## ADDENDUM #2

### REQUEST FOR PROPOSALS: GENERAL CONTRACTOR SERVICES FOR THE PUBLIC WORKS COMPLEX

**CLEARFIELD CITY PUBLIC WORKS COMPLEX PROJECT:  
OPERATIONS BUILDING - SECTION 1**  
497 SOUTH MAIN STREET  
CLEARFIELD, UTAH 84015

BID SET - SECTION 1  
SHEET TITLE:  
**ENLARGED STAIR PLANS/ SECTIONS**  
SHEET NUMBER:  
**A311**  
© 2022 THINK ARCHITECTURE, INC.

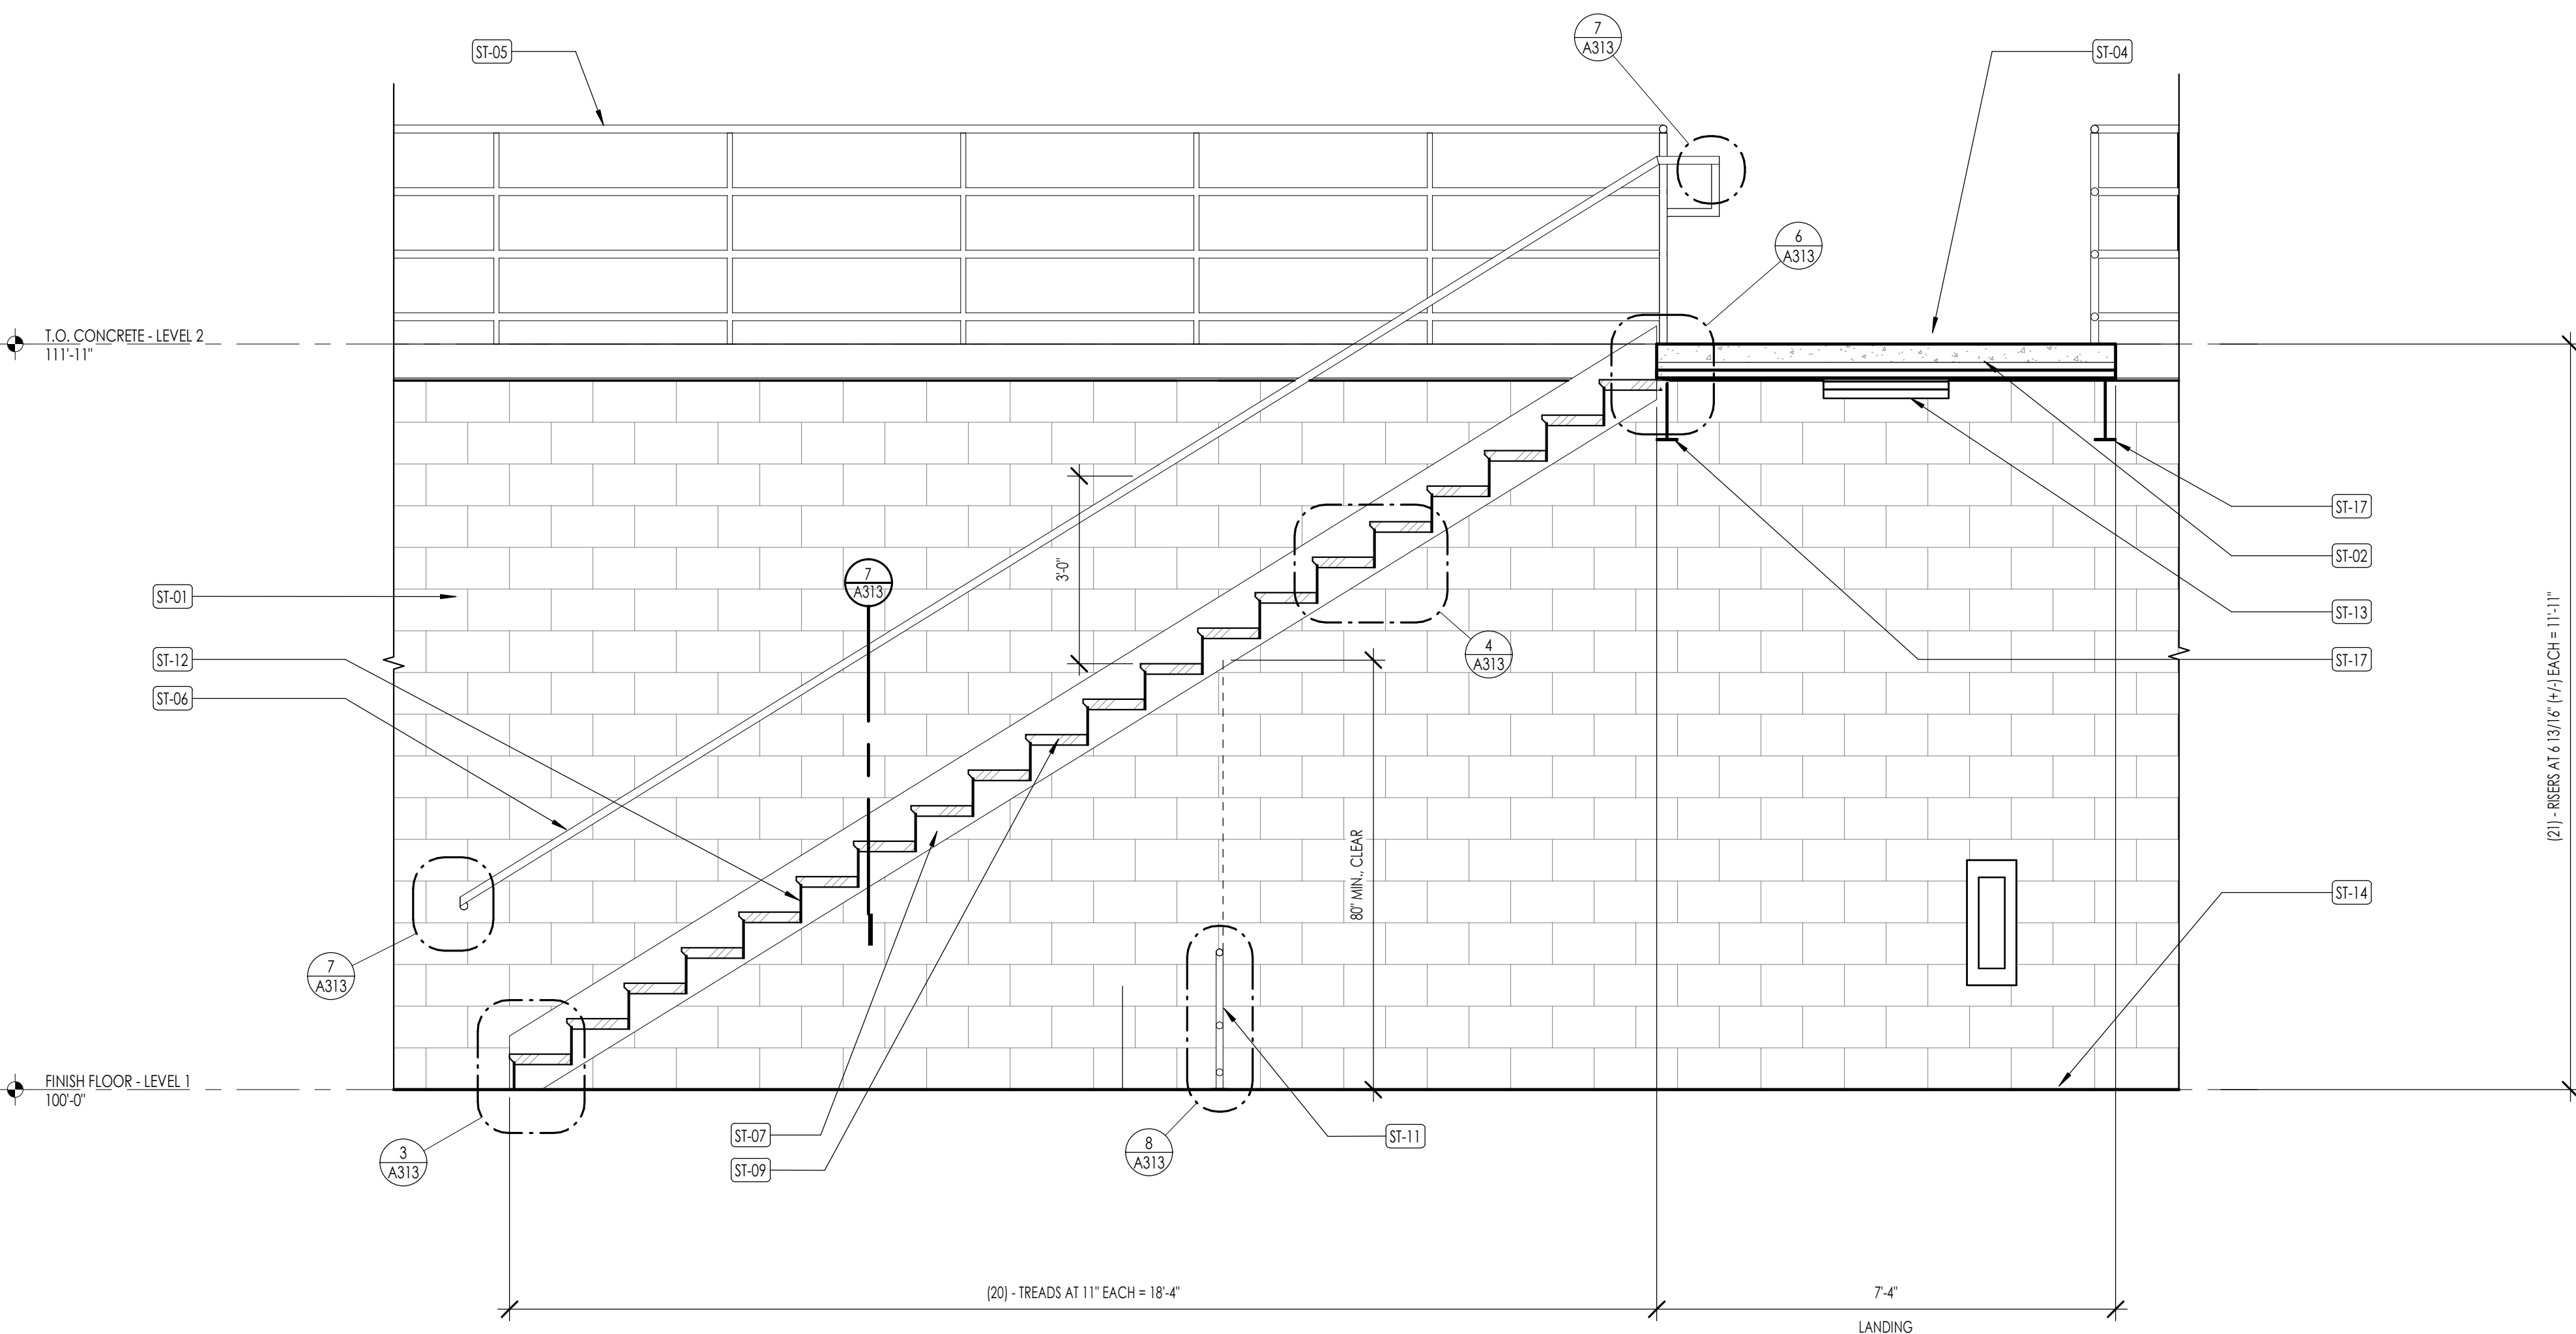
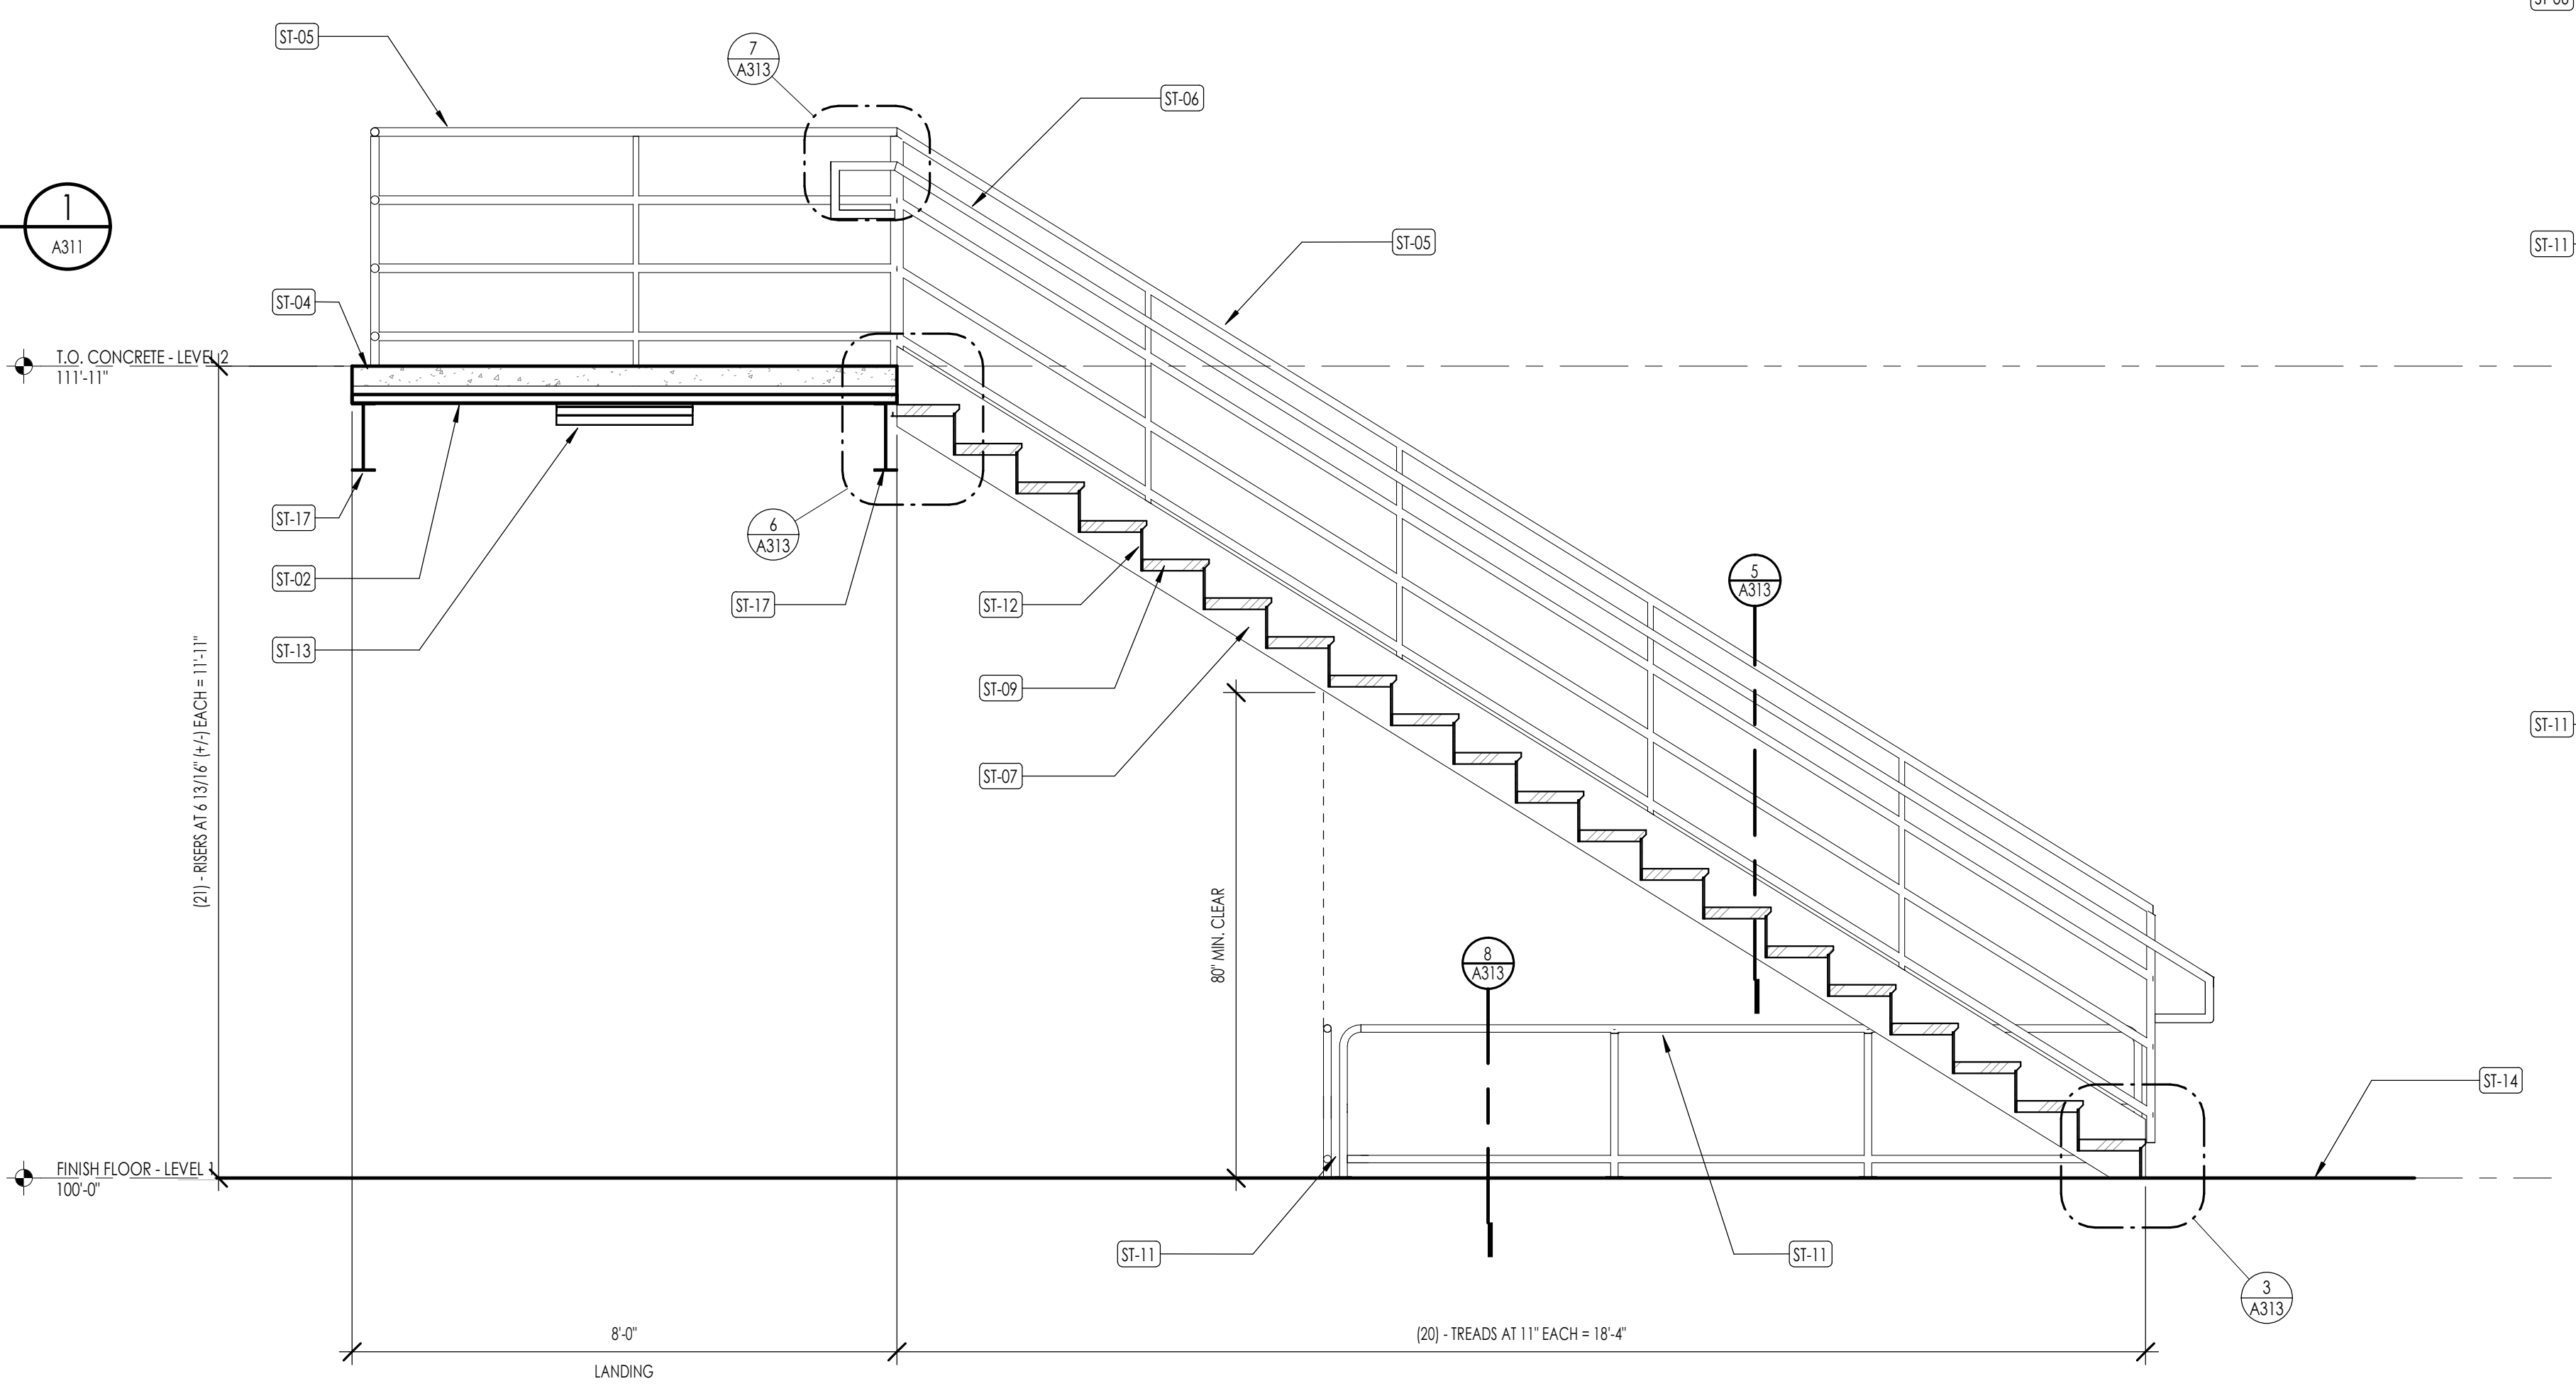
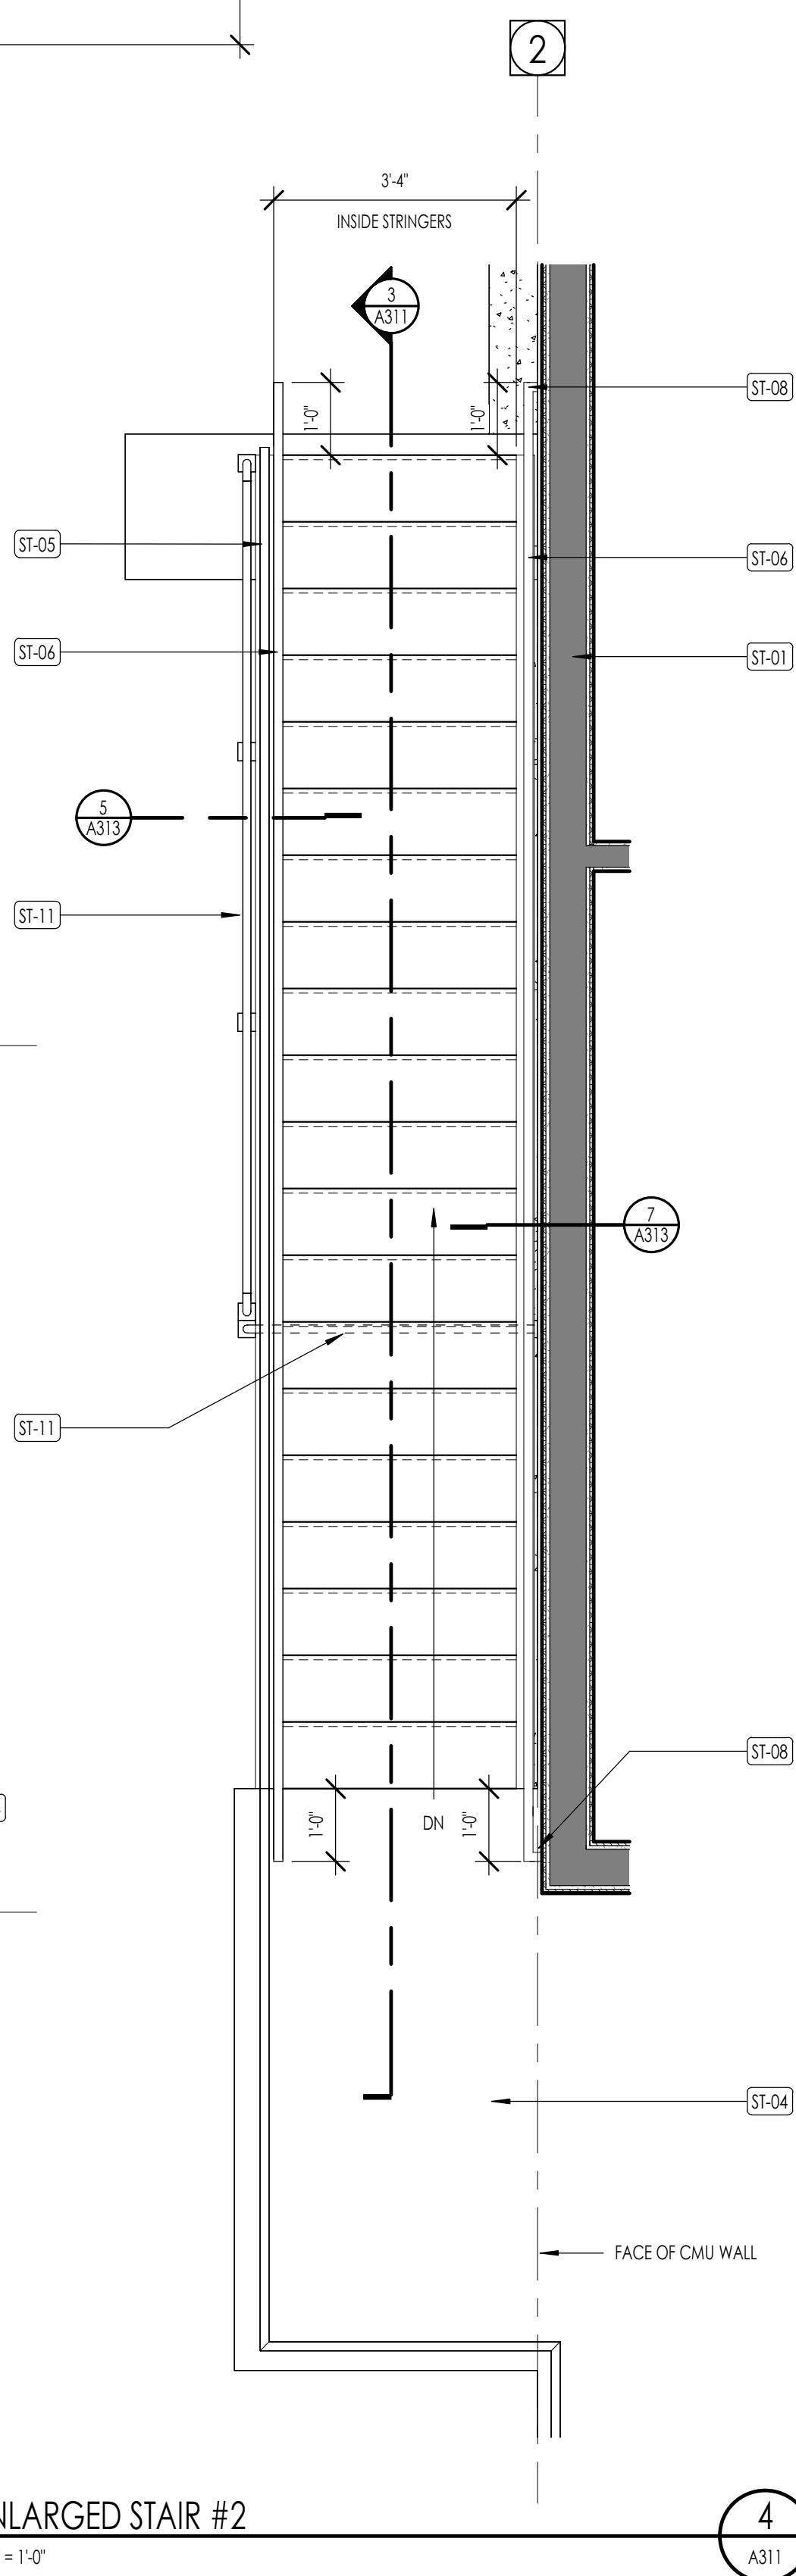
4. **Attachment D – Section 1 Operations Building (Project Drawings)** have been updated and a copy is attached. The following sheets have been revised and shall replace the original sheets: Sheets A311, A312, A313, A601, S002, S101A, S101B, S101C, S111A, S111B, S121A, S121B, S121C, S511, S521, S522, S601, S602, and S603. Changes have been clouded.
